Project Submittal Interim Form

Fayetteville Outer Loop

Subject: **Request for Modification to Individual Section 404 and Section 401 Water Quality Certification** for Fayetteville Outer Loop from I-95 South of Fayetteville to NC 24-87, Cumberland, Hoke, and Robeson Counties. Federal Aid Project No. NHP-0620(031), State Project No. 34817.3.13, TIP Nos. X-0002 B & C, and U-2519 AA, AB, BA, BB, CA, CB, DA, & E, and I-5987. Debit \$570 from WBS 34817.3.13

**Minutes from the Interagency 4C Permit Review Meeting
U-2519AA & AB – Cumberland and Robeson Counties
Meeting Date: May 11, 2022
Minutes Date: June 9, 2022**

SITE 22C

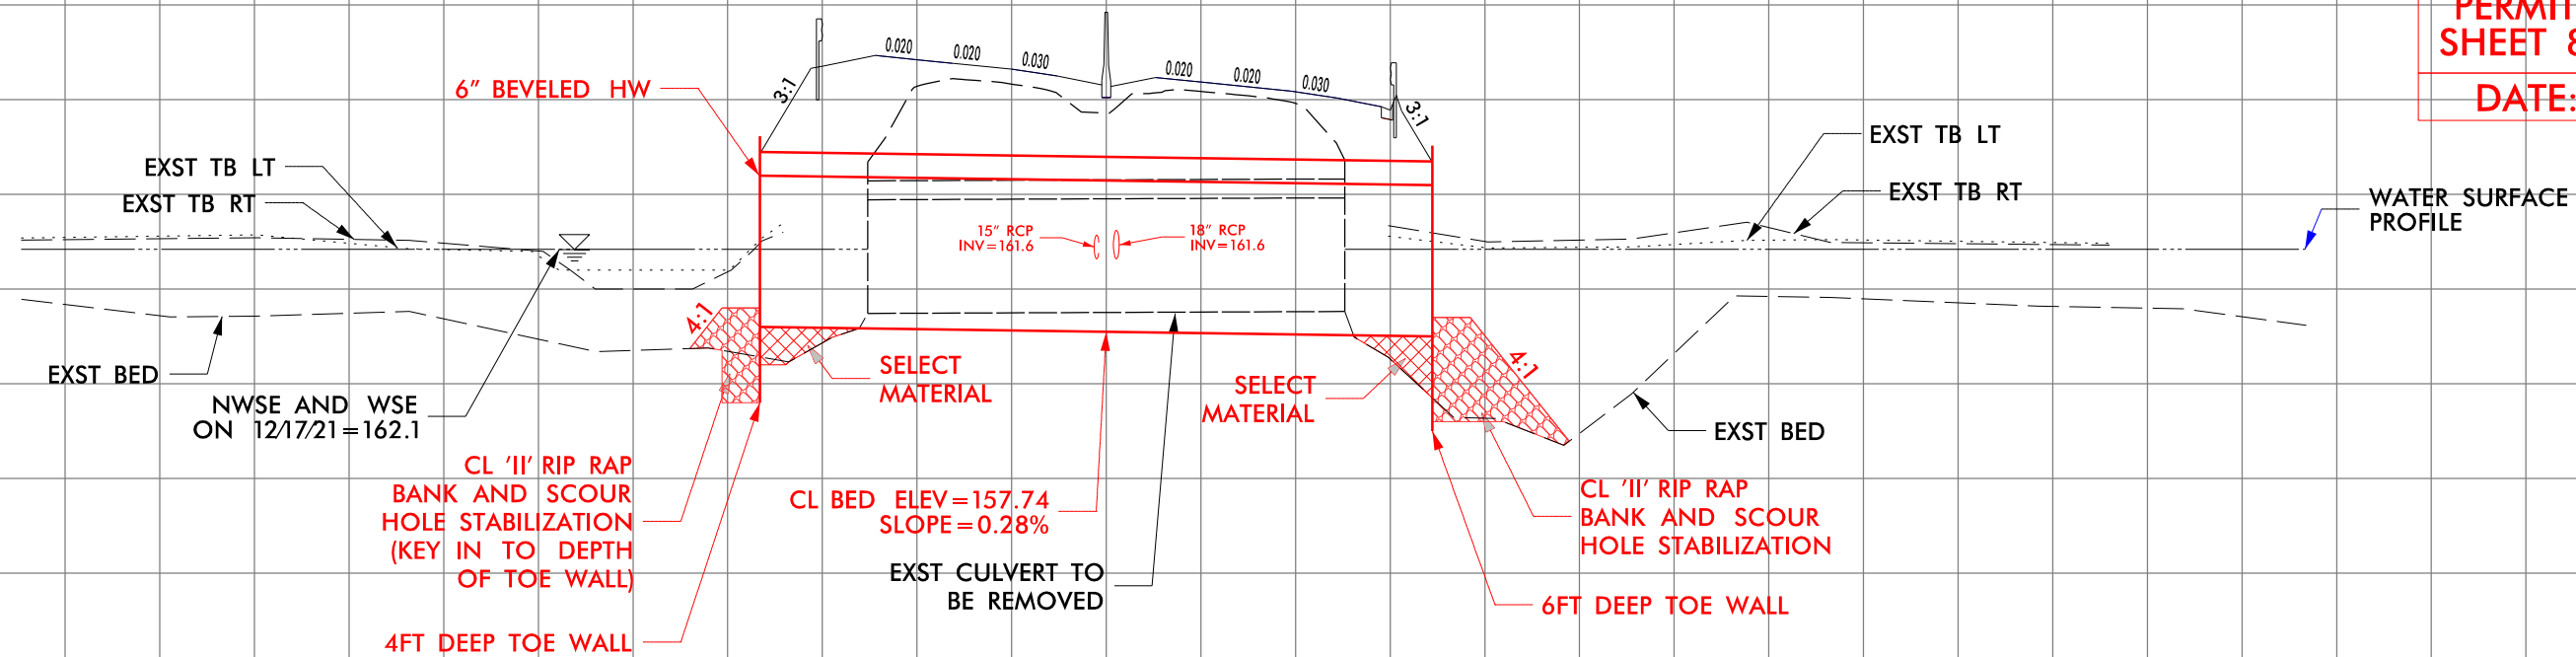
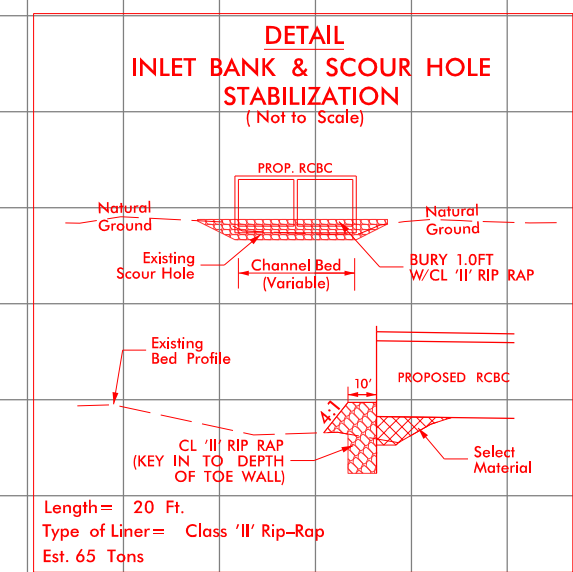
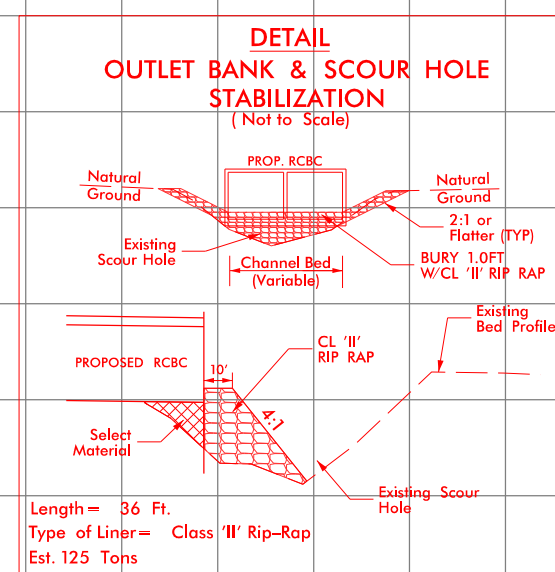
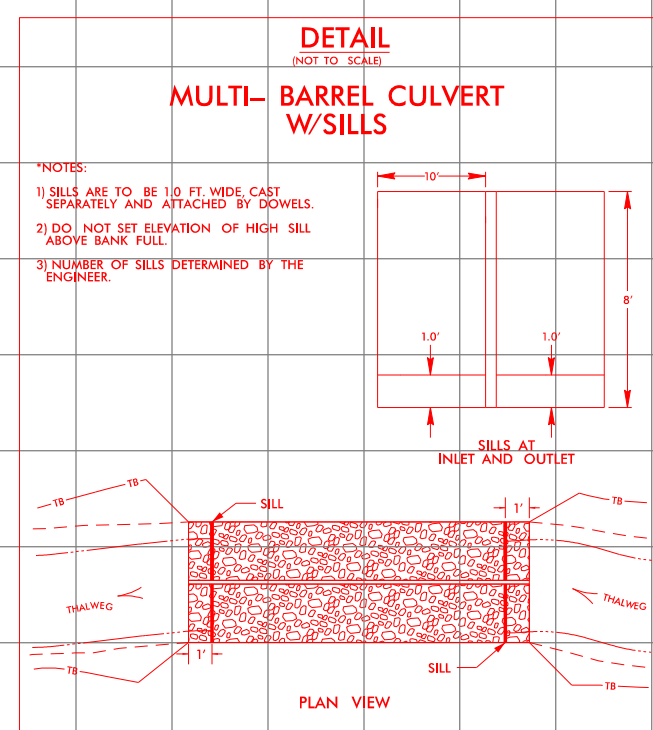
- Sheet 2 of 21 – Site 22C – Station 99+60 -Y-:
 - David Talbert – Existing 1@7'x6' Reinforced Concrete Box Culvert is to be removed. The proposed 2@10'x8' RCBC will have a beveled headwall and 1' sills at the inlet and outlet. The culverts are to be backfilled to a depth of 1' with native bed material. All backfill material shall be reviewed by the DEO and shall consist of native material only unless the Engineer in consultation with the DEO determine the native material is either unsuitable or additional material is required to supplement the native material. A 6' toe wall will be installed at the outlet end of the proposed culvert. The inlet and outlet of the existing and proposed culverts are perched due to scour, therefore, Class II rip rap will be utilized as scour hole stabilization and will tie to the existing stream bed at a 4:1 slope.

SITE 32

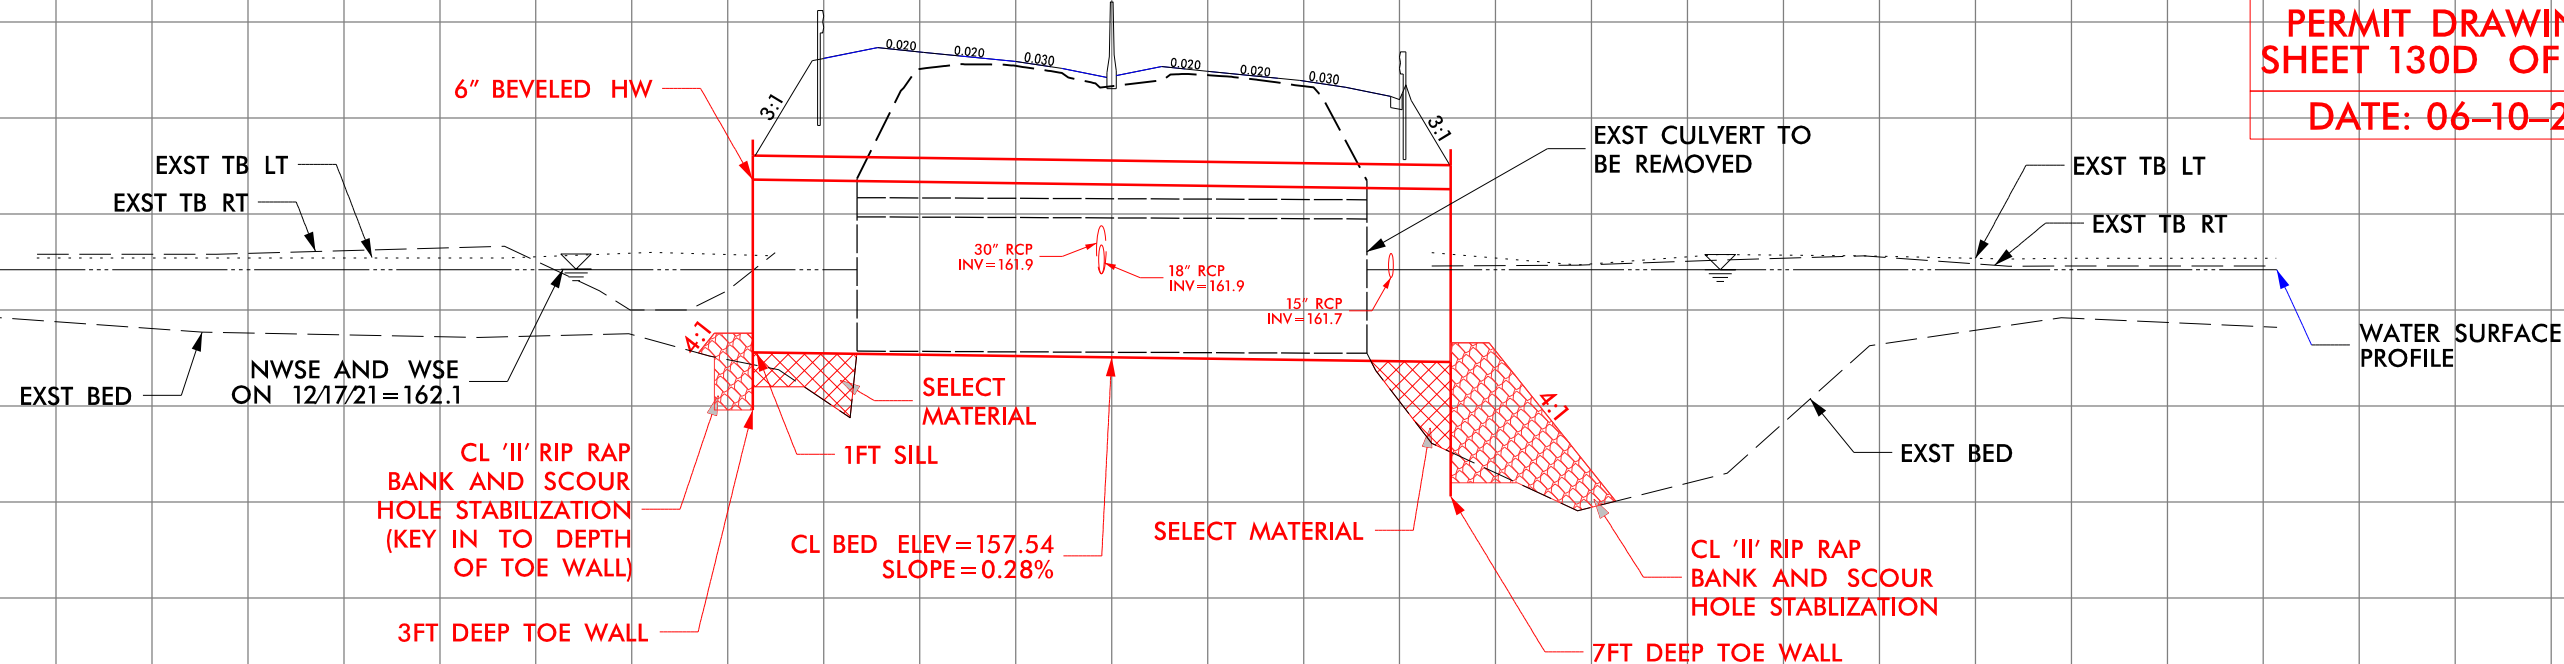
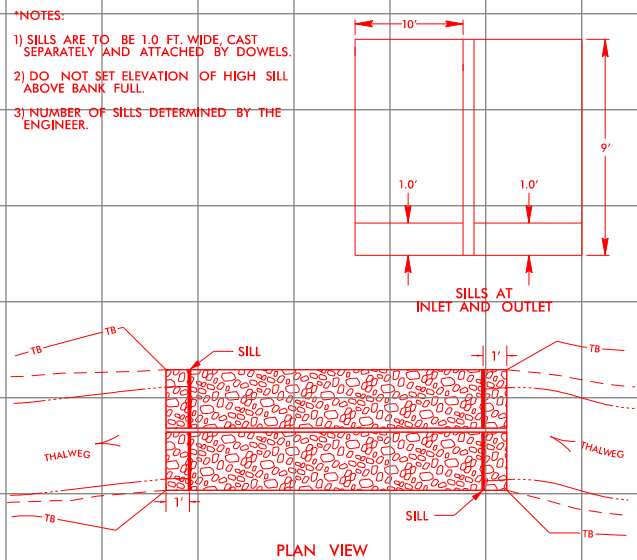
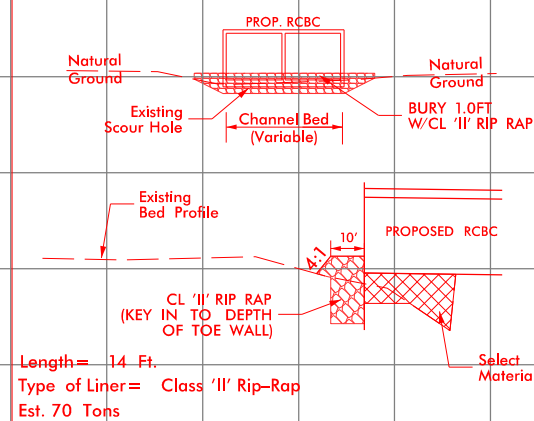
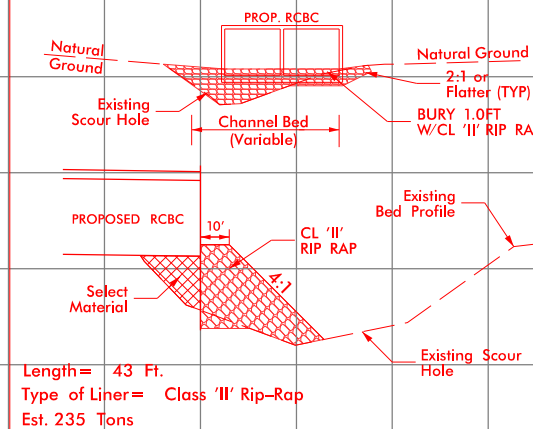
- Sheet 8 of 21 – Site 32 – Station 108+30 -Y-:
 - David Talbert – Existing 1@9'x7' Reinforced Concrete Box Culvert is to be removed. The proposed 2@10'x9' RCBC will have a beveled headwall and 1' sills at the inlet and outlet. The culverts are to be backfilled to a depth of 1' with native bed material. All backfill material shall be reviewed by the DEO and shall consist of native material only unless the Engineer in consultation with the DEO determine the native material is either unsuitable or additional material is required to supplement the native material. A 7' toe wall will be installed at the outlet end of the proposed culvert. The inlet and outlet of the existing and proposed culverts are perched due to scour, therefore, Class II rip rap will be utilized as scour hole stabilization and will tie to the existing stream bed at a 4:1 slope.

- Hannah Sprinkle asked if any consideration had been given to the skew at which Cold Camp Creek approaches the inlet of the proposed culvert.
 - David Talbert and Michael Penny responded that the headwall design and the Class II rip rap would be sufficient in preventing any bank scour at this location. Michael Penny noted this was looked into in the initial design phase but was decided against in order to reduce impacts.

SITE 33

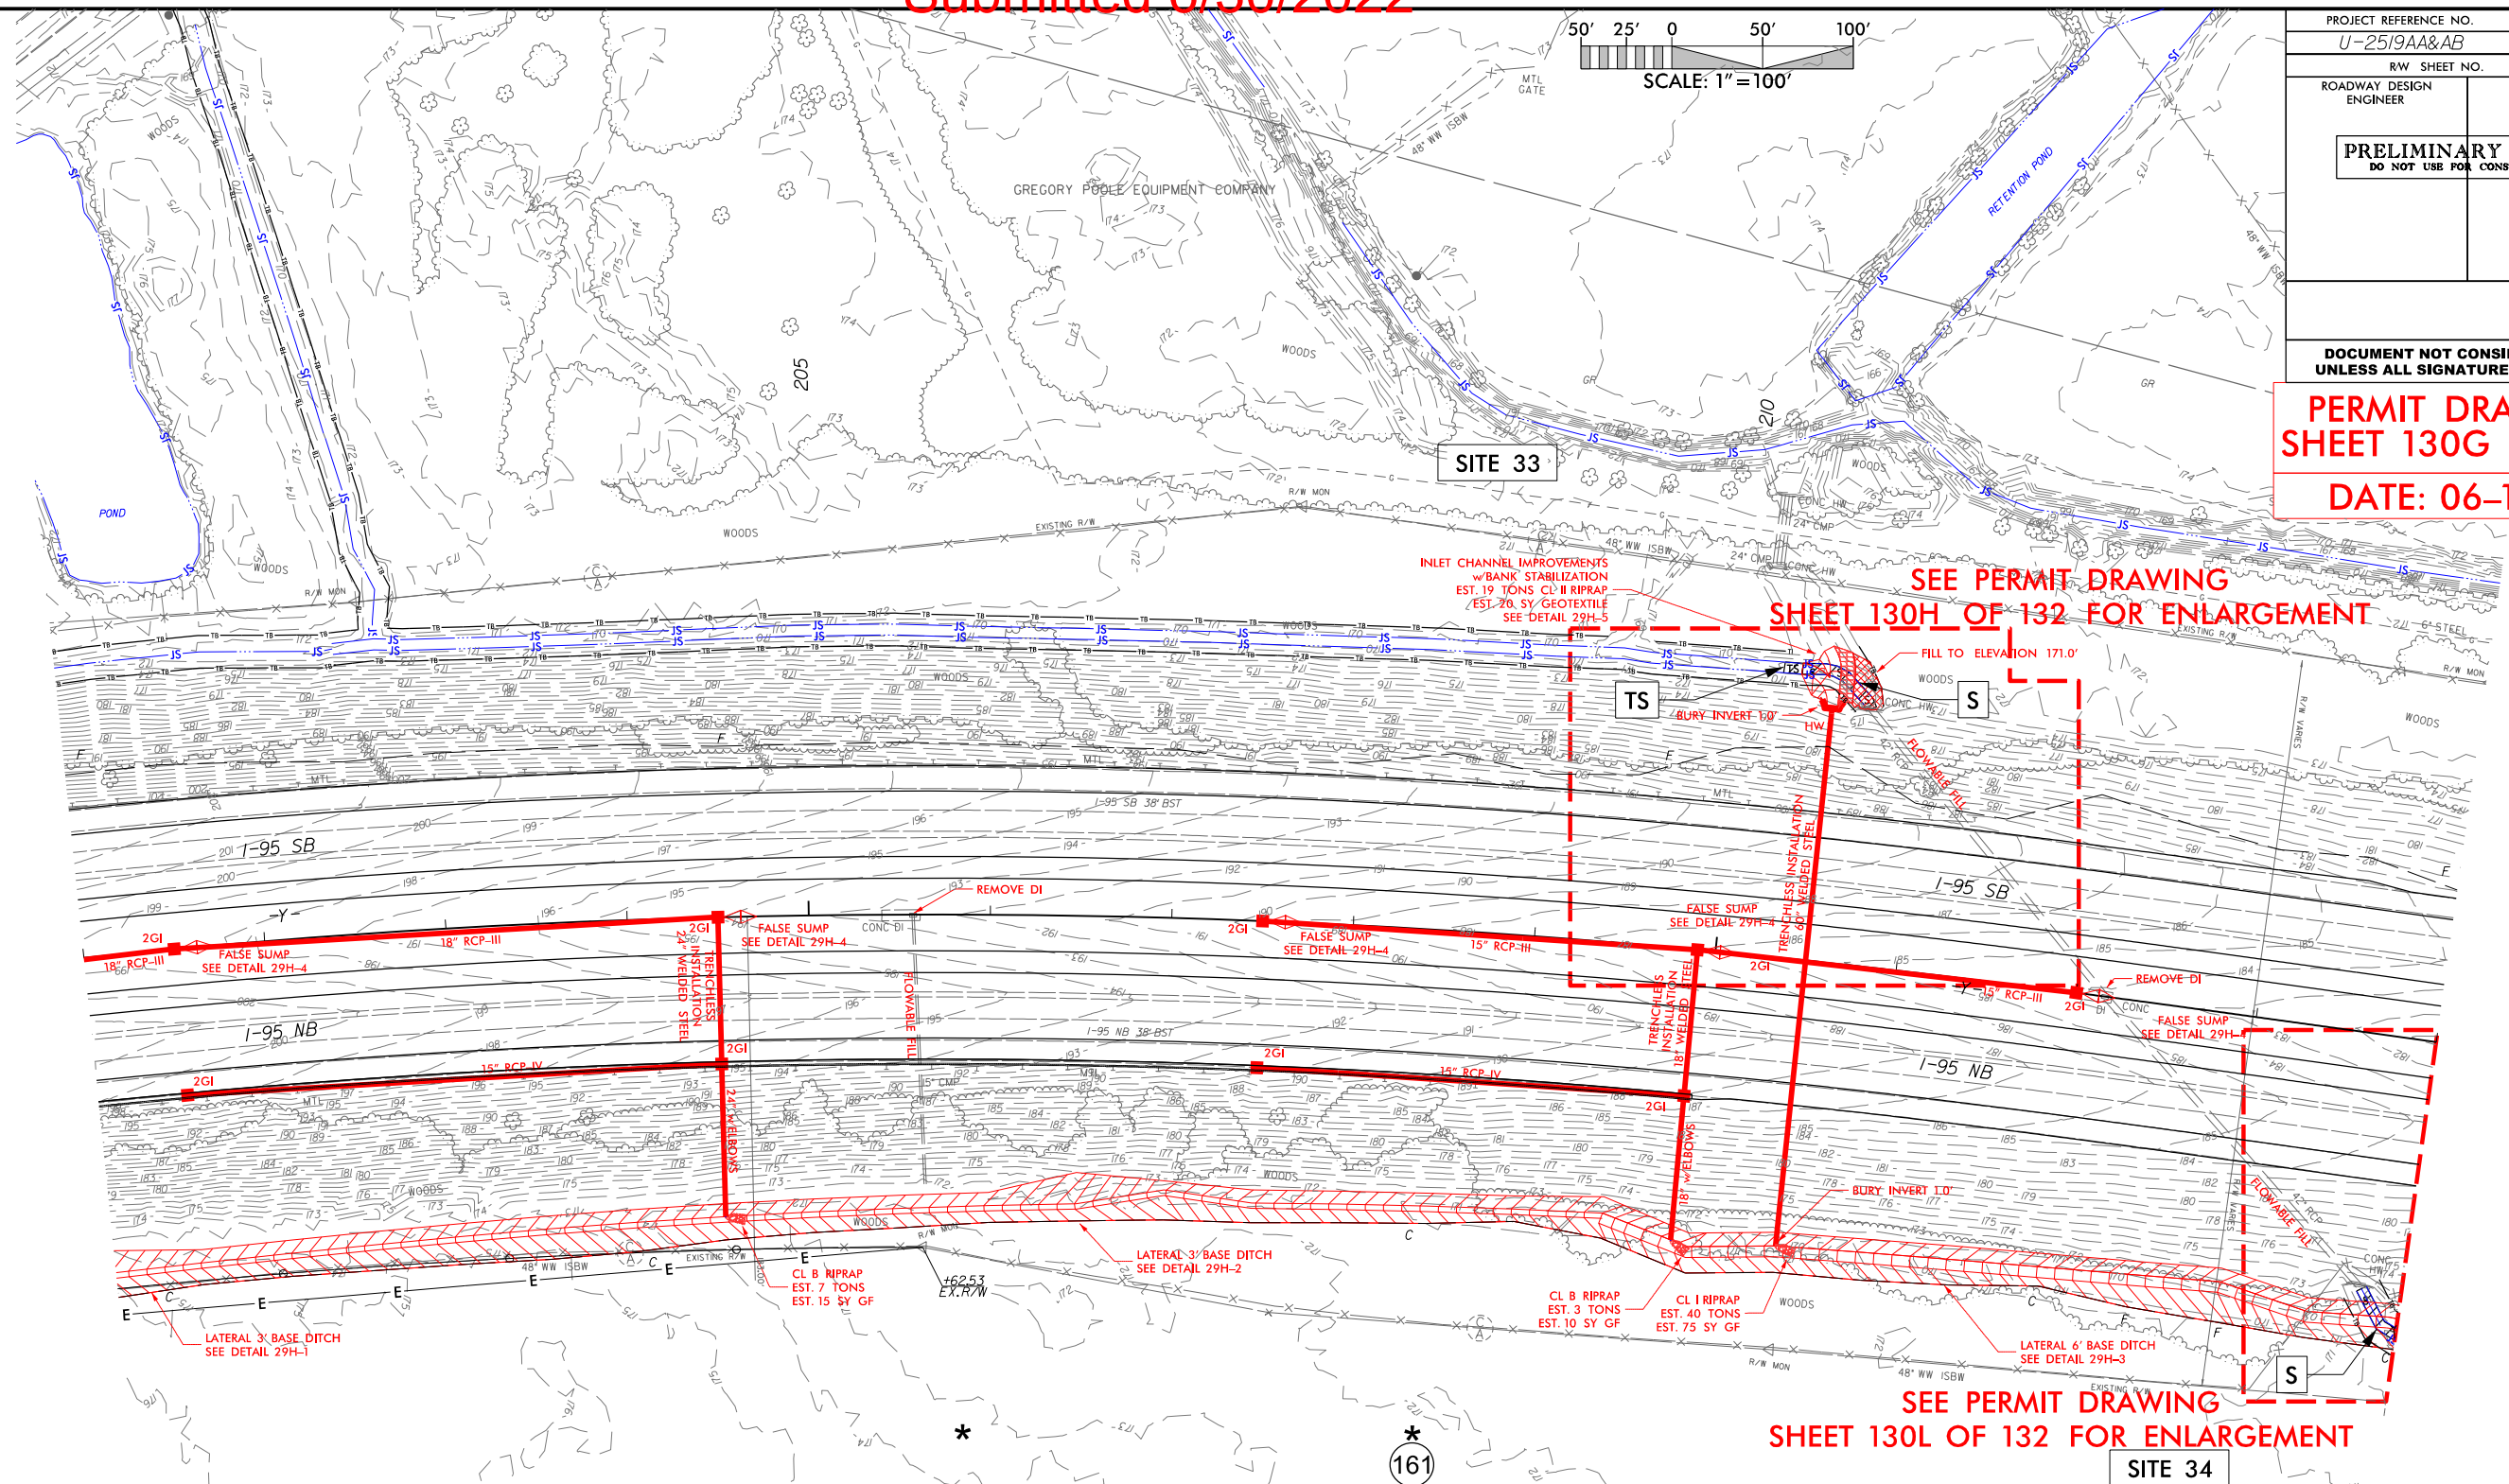
- Sheet 14 of 21 – Site 33 – Station 210+50 -Y- LT:
Site 34 – Station 214 -Y- RT:
 - Eric Leonhart – The existing 42" Reinforced Concrete Pipe is to be flow filled and replaced with a proposed 60" Welded Steel Pipe that buried 1'. The existing 42" RCP is perched, therefore, there is proposed channel

work and bank stabilization will be installed on the upstream side of the 60" WSP to provide a smooth transition from the existing stream to the proposed pipe.

- Eric Leonhart noted that on West side of I-95 (upstream), the stream is a Jurisdictional Non-Mitigable, therefore, impact totals are only calculated and shown on the Wetland Impact Summary Table as an acreage quantity. On the East side of I-95 (downstream), Grays Creek is a Jurisdictional stream so stream impact totals are quantified as both linear feet and an acreage quantity.

- Due to the existing stream bed elevations and alignment of the existing structure, the proposed 60" WSP will be installed at a 0.0% slope and will include a stream realignment on the downstream side. The proposed stream realignment will be constructed at a 0.0% slope in order to provide positive drainage to tie with Grays Creek.

- Sheet 17 of 21 – Site 33 – Station 210+50 -Y- LT:
Site 34 – Station 214+50 -Y- RT:
 - James Rerko noted the scale of the proposed 60" Welded Steel pipe on the profile along culvert sheet may be incorrect. Eric Leonhart concurred and noted the scale will be adjusted to show the proposed 60" WSP correctly.
